STAFF REPORT
COMMUNITY DEVELOPMENT DEPARTMENT

HEARING DATE: 6/22/2021
 TO: Mayor & City Council
 FROM: Joe Dodson, Associate Planner
 208-884-5533
 SUBJECT: H-2021-0021
 Prevail North Subdivision

Annexation & Zoning of 5.63 acres of land with an R-8 zoning district and a preliminary plat consisting of 18 single-family residential lots and 3 common lots on 5.25 acres of land.

B. Preliminary Plat (dated: 5/7/2021)

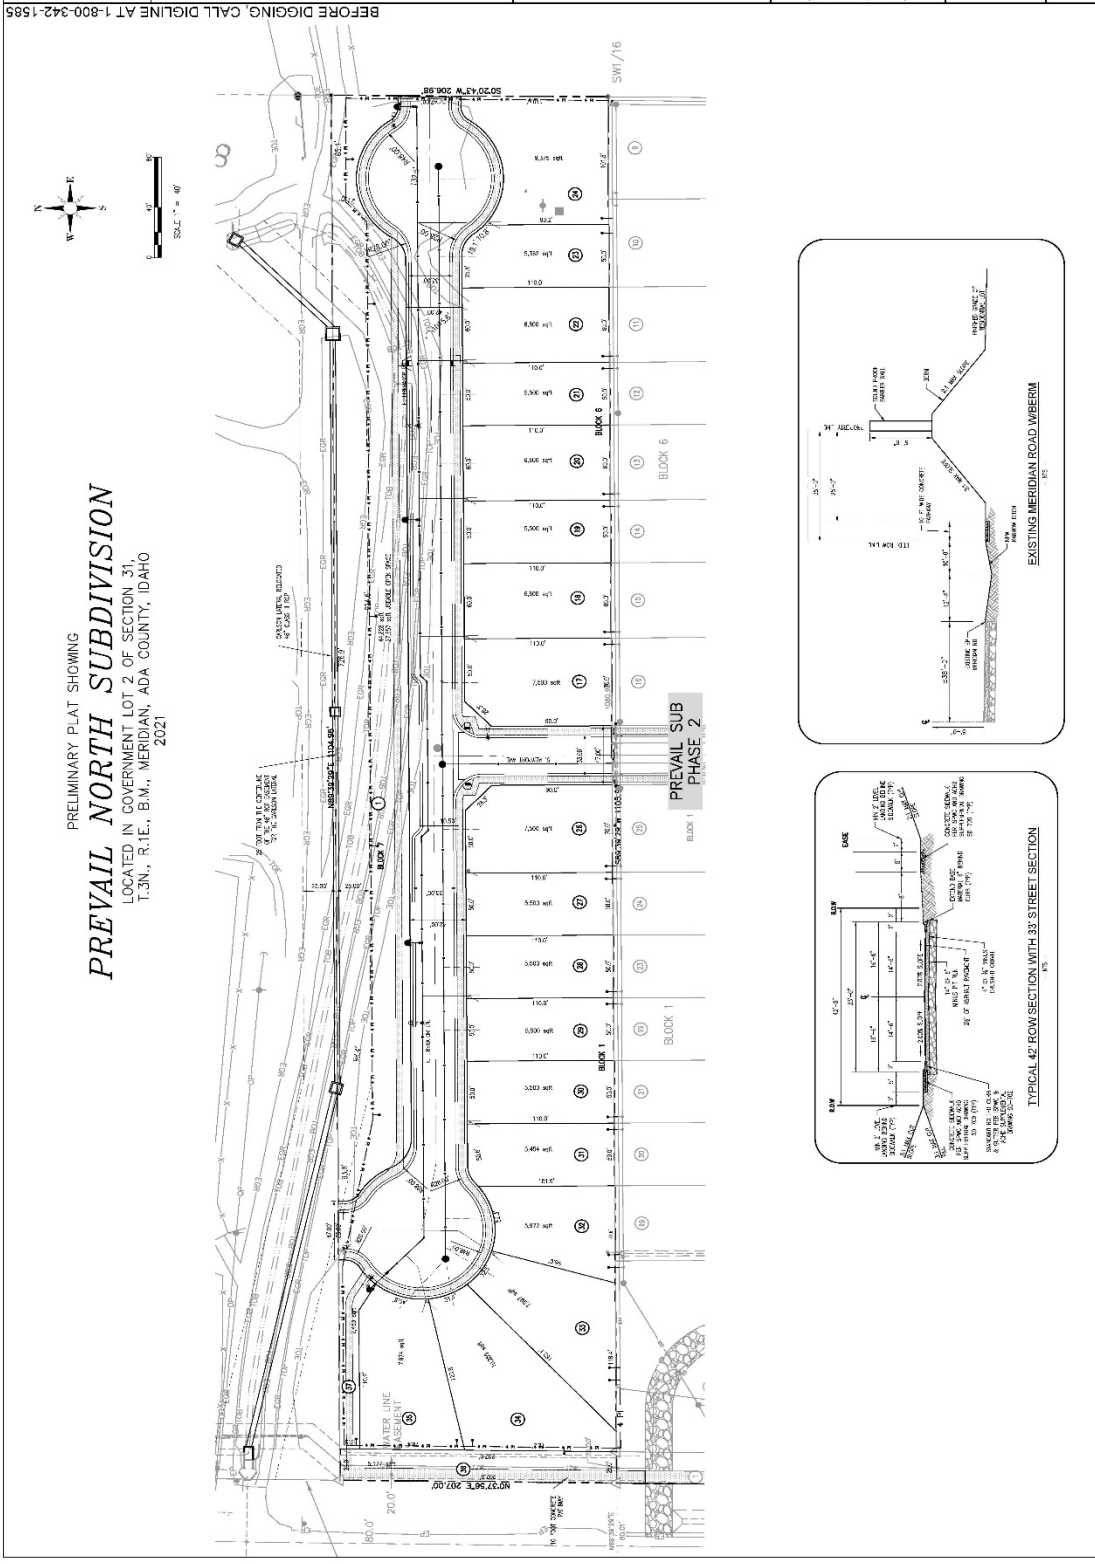
2. The preliminary plat included in Section VII.B, dated May 7, 2021, shall be revised as follows prior to submitting for Final Plat approval:
 - a. Revise the plat to show the landscape buffer common lot along Meridian Road to be at least 35 feet wide consistent with the required dimensional standards along an entryway corridor or apply for Alternative Compliance, per UDC 11-5B-5.

- b. Add a plat note stating that direct lot access to S. Meridian Road/SH 69 is prohibited.
 3. ~~Revise the landscape plans, open space exhibit, and all other relevant plans to reflect the revised preliminary plat layout and provide revised plans to staff **at least fifteen (15) days prior to the City Council hearing.**~~

D. Color Landscape Plan – Prevail Subdivision Overall

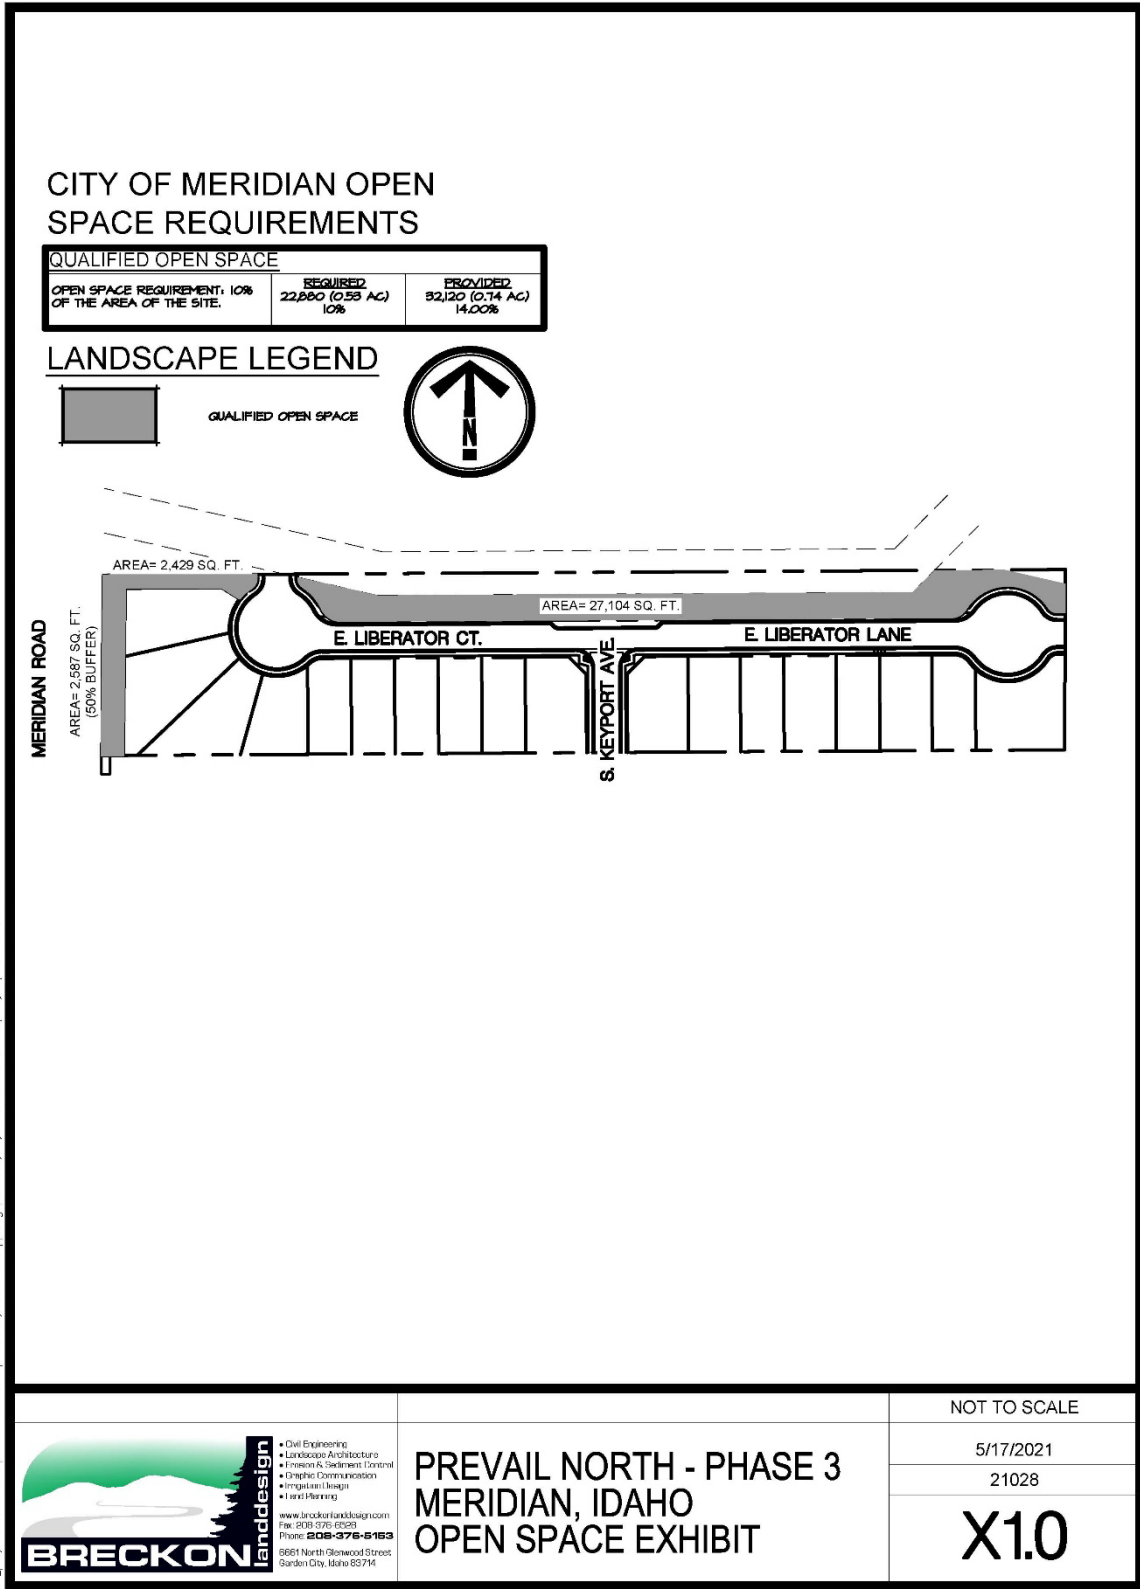
The proposed 8-foot wide parkway is approximately 740' in length on the revised plat requiring at least 21 trees (1 per every 35 linear feet). The submitted landscape plan does not show compliance with this requirement because it is shown with less than 21 trees. In addition, the plat

has been revised since the original application submittal and the submitted landscape plans have not been revised to match the new road layout. Regardless, the Applicant should revise the landscape plans prior to the City Council hearing to ensure they match the revised preliminary plat and show compliance with the landscaping requirements.

In addition, common open space is required to be landscaped with one (1) tree for every 8,000 square feet of open space. The large open space area is shown as 32,709 square feet in the development table on the preliminary plat. However, Staff's area analysis shows a figure closer to 36,500 square feet. Based on Staff's calculation, the minimum number of trees that are required within the open space lot is five (5) trees. The submitted landscape plans show six (6) trees proposed exceeding the minimum UDC requirements.

The landscape buffer along Meridian Road is required to be 35' wide and contain the required multi-use pathway within it. The submitted landscape plans show compliance with UDC requirements for the number of trees, tree spacing/grouping, and additional vegetative ground cover. However, the Applicant is only showing a 25' wide common lot on the preliminary plat for the required street buffer. Therefore, the Applicant should correct both the plat and the landscape plans to depict the required 35' wide buffer.

The Applicant is also proposing a micro-pathway from the western cul-de-sac to the multi-use pathway and does not appear to have the correct landscaping. UDC 11-3B-12 requires that trees be placed on both sides of the pathway; the Applicant has only proposed trees on the south side of the pathway. Staff is not aware of any easements encumbering the north side of the pathway and the landscape strip appears to be the minimum 5-foot width. Therefore, the Applicant should move one of the trees to the other side of the micro-path; Staff recommends the center tree of the three currently shown on the south side of this pathway.

Although there is no code requirement for this change, Staff also recommends removing the shrub bed located in the center of the large open space lot. By removing this planter bed and the shrubs there would be an unobstructed area in the center of the open space lot that is at least 9,000 square feet in size; it is rare for a subdivision to provide an area this large for children to play in without obstruction. If the Applicant desires to still include the same number of shrubs as currently shown, they could disperse them to the planter beds shown further to the west and east on the landscape plan.

4. The landscape plan included in Section VII.C, dated ~~March~~ May 17, 2021, shall be revised as follows prior to submitting for Final Plat approval:

- a. Revise the plan to show the required landscape buffer along Meridian Road to be 35' instead of 25' or apply for Alternative Compliance, per UDC 11-5B-5.

- b. ~~Move one of the trees located on the south side of the micro pathway in the northwest corner of the site to the north side of the pathway consistent with UDC 11-3B-12.~~

- c. ~~Remove the center planter bed within the large open space lot, shown as Lot 1, Block 7.~~
 - d. ~~Plant the proposed 8 foot wide parkway along the north side of Liberator Street with at least one (1) tree per 35 linear feet consistent with UDC 11-3B-7C.~~

E. Open Space Exhibit — ~~NOT APPROVED~~ dated: 5/17/2021

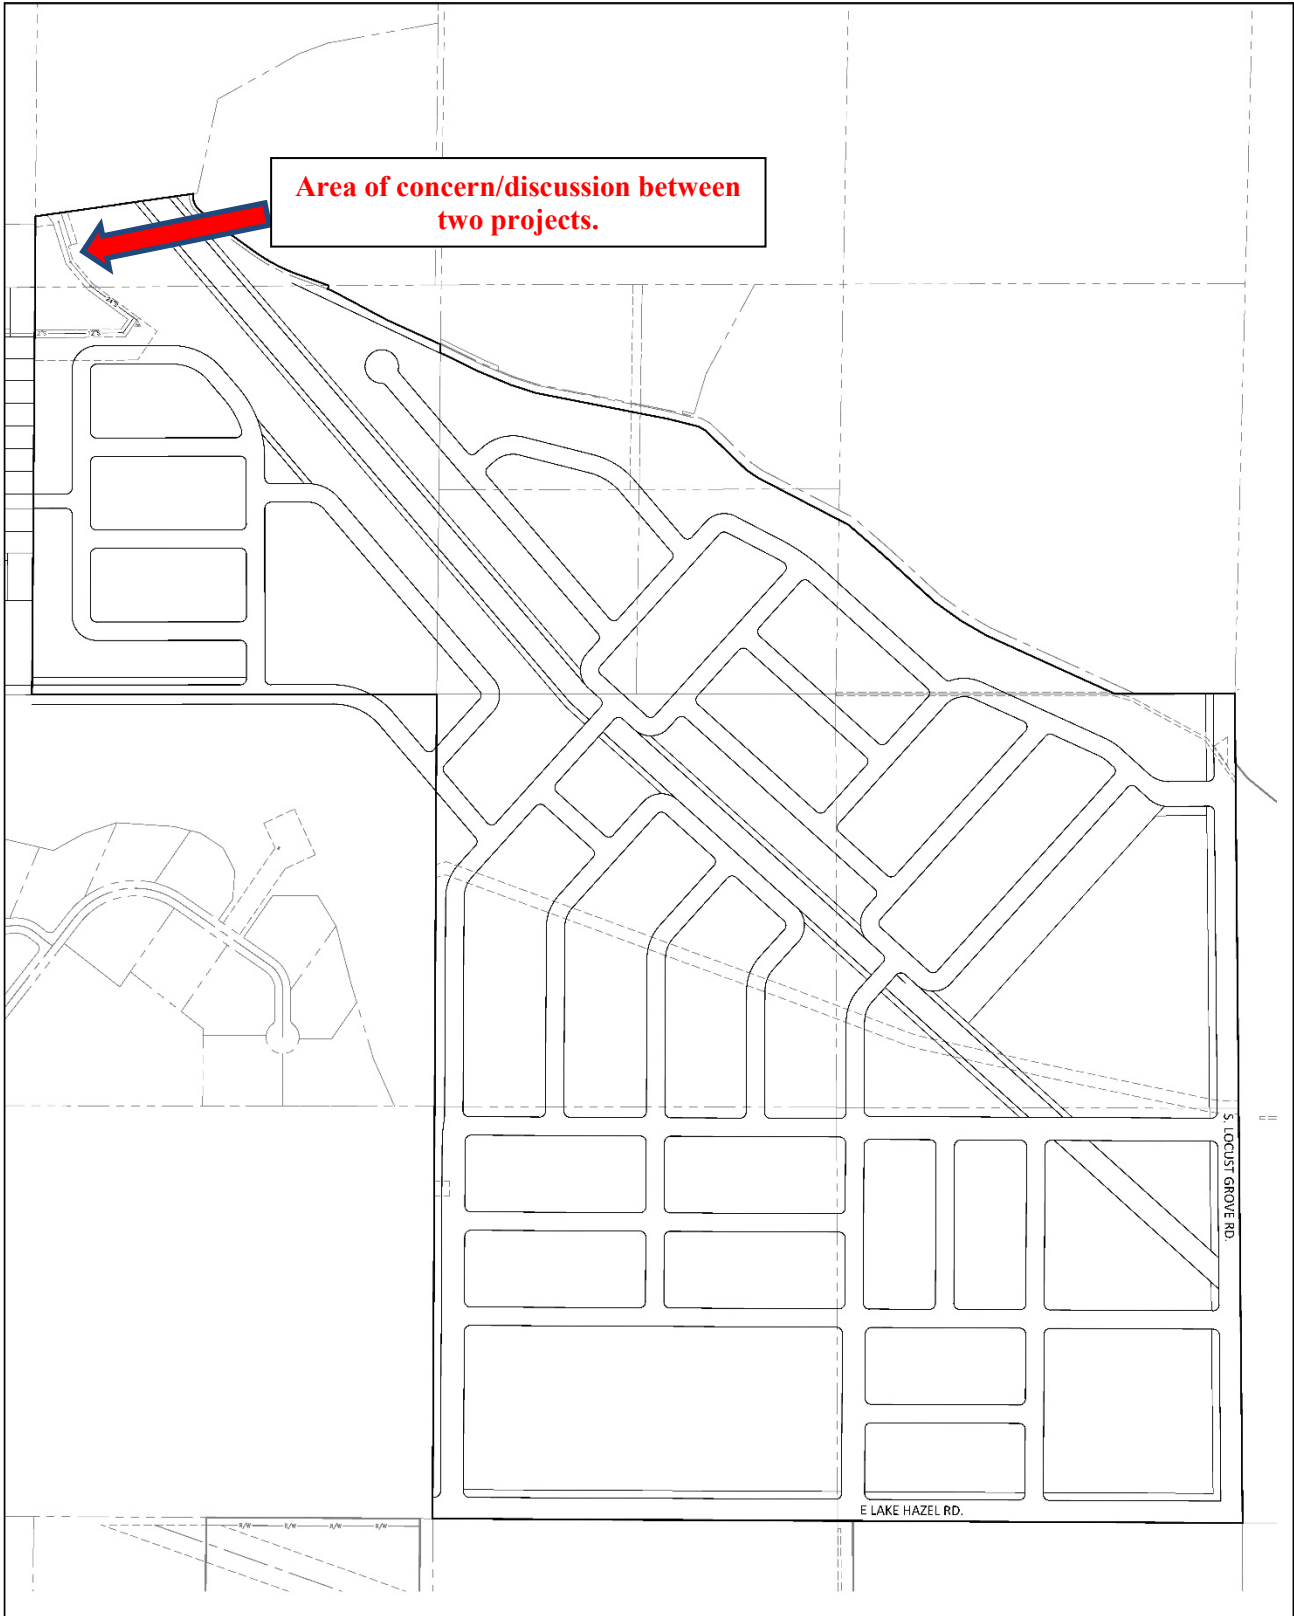
of the 5.25 plat area. However, not all of this area is qualifying after receiving the revised landscape plan that fences off a section of the open space lot that is impeded by the irrigation easement for the rerouted Carlson Lateral. After removing this area, the area of qualified open space is 32,120 square feet (0.74 acres) or 14% of the plat area. The proposed qualified open space still exceeds the minimum code requirements by approximately 10,000 square feet. Furthermore, this calculation uses the 25' landscape buffer width along Meridian Road instead of the required 35' width. Therefore, the actual amount of qualified open space should be slightly larger. The Applicant should correct the open space exhibit to reflect both the revised layout and the correct amount of qualified open space.
